Arizona Nuclear Power Project

Corrected Copy

Subject: Palo Verde Nuclear Generating Station (PVNGS)
Units 1, 2 and 3
Docket Nos. STN-50-528/529/530
File: 84-056-026; G.I.01.10

Reference: Letter from G. W. Knighton, NRC, dated
October 6, 1984
Subject: Request for Additional Information-
PVNGS Technical Specification

Figure
15.4.1-2

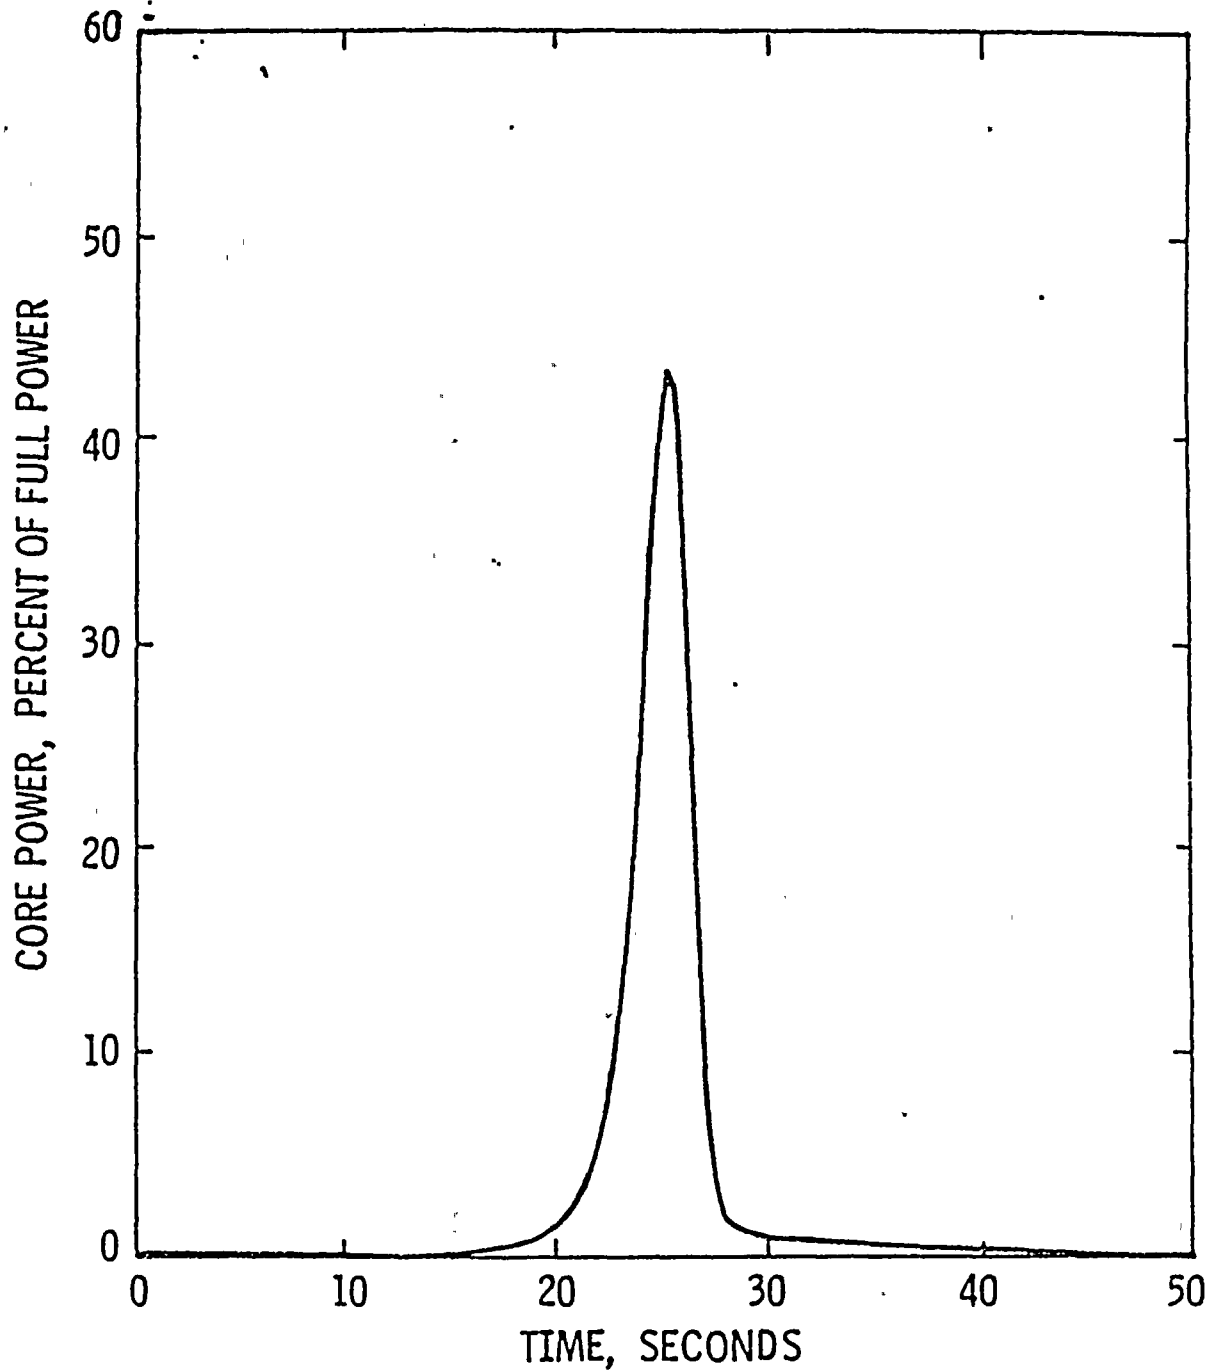
1. Reactor Protective Instrumentation Setpoints (Table 2.2-1, Section 2.2, page 2-3 and 2-4)
 - A. Provide basis for the trip setpoint of the high pressurizer pressure on the Supplementary Protection System (SPS).
 - B. Table 15.0-4 of the FSAR indicates that the analysis setpoint of the high pressurizer pressure trip is 2450 psia. Explain how the SPS pressurizer pressure-high with an allowable value of ≤ 2439 psia plus instrument uncertainty could ensure the plant operation within the conditions covered by the safety analysis.
 - C. Confirm that the overpower setpoint in Table 15.0-4 of the FSAR will be modified to 11%.
 - D. Provide basis of the variable overpower allowable setpoint value of 11.0%/min in light of the safety analysis assumptions.

- D. In the Chapter 15 safety analysis, two events credit a reactor trip on the variable overpower band setpoint. The band setpoint used in these analyses is 17%. The uncontrolled CEA withdrawal from a low power condition in Section 15.4.1 of the CESSAR FSAR credited this reactor trip. In addition, the CEA Ejection analyses implicitly credited this reactor trip for the purposes of determining that a CEA Ejection at Hot Full power is more limiting than a CEA Ejection at hot zero power. Because the CEA Ejection at hot full power is more limiting, it is presented in CESSAR FSAR Section 15.4.8. The variable overpower band setpoint used in the Safety Analysis (17%) is conservative with the Technical Specification maximum allowable band setpoint of 10%.

The maximum rate at which the variable overpower band setpoint can increase is 11% per minute. For any safety analysis transient crediting the variable overpower band setpoint, this 11% per minute maximum rate of increase has negligible impact on the results. As an example, consider the impact of this rate setpoint on the slower of the two transients discussed above, the uncontrolled CEA withdrawal from a low power condition (Section 15.4.1). From CESSAR-F Figure 15.4.1-2, it can be seen that the core power does not increase appreciably above 0% for the first 15 Seconds. Between 15 and 23.4 seconds (time of trip) core power increases exponentially. During this approximately 10 sec period the maximum increase of the band trip setpoint is $(10 \text{ sec}/60 \text{ sec/min})$ (11%/min) or 1.8%. As can be seen from Figure 15.4.1-2 the additional amount of time required to increase core power to 18.8% instead of 17% is extremely small due to the exponentially increasing behavior of core power. Because of the more rapid rate of increase of core power for the zero power CEA ejection transient, it is therefore concluded that the rate setpoint of 11% per minute has no adverse impact on the safety analysis.
